Standardized Information for Process/Product Change Notification (PCN)

1. PCN basic data		
1.1 Company		YAGEO Group No. 16, West. 3rd St., Nanzi Dist., Kaohsiung (N.T.I.P.) 811626, Taiwan
1.2 PCN No.	EBR-26004	
1.3 Title of PCN	Add SZ Production Site and Material System of CC / X7R / 1206 / 100V / 2.2μF	
1.4 Product Category	MLCC CC X7R Series	
1.5 Issue date	24-Mar-26

YPN
CC1206KKX7R0BB225

ESR/Z

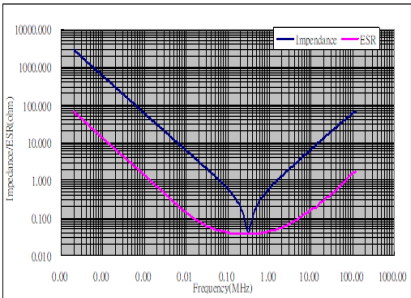
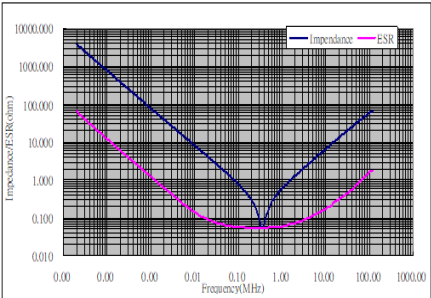
Original Design

New Design

Construction
31-142-34

35-124-35

VCC

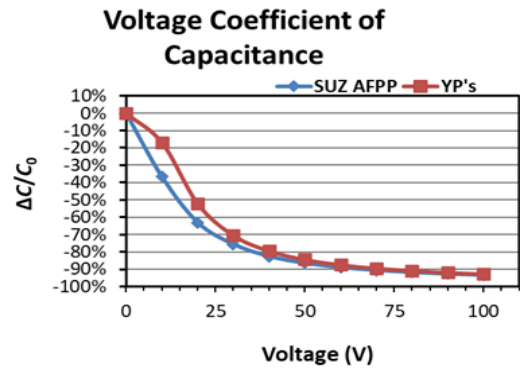
New
Original

Electrical characteristic		Original						New	
	Spec	Avg.	Max.	Min.	Avg.	Max.	Min.		
D.F	5%	3.10%	3.22%	3.03%	2.62%	2.70%	2.56%		
I.R.	45 M ohm	318 M ohm	349 M ohm	299 M ohm	765 M ohm	830 M ohm	710 M ohm		
BDV		464	500	420	701	772	653
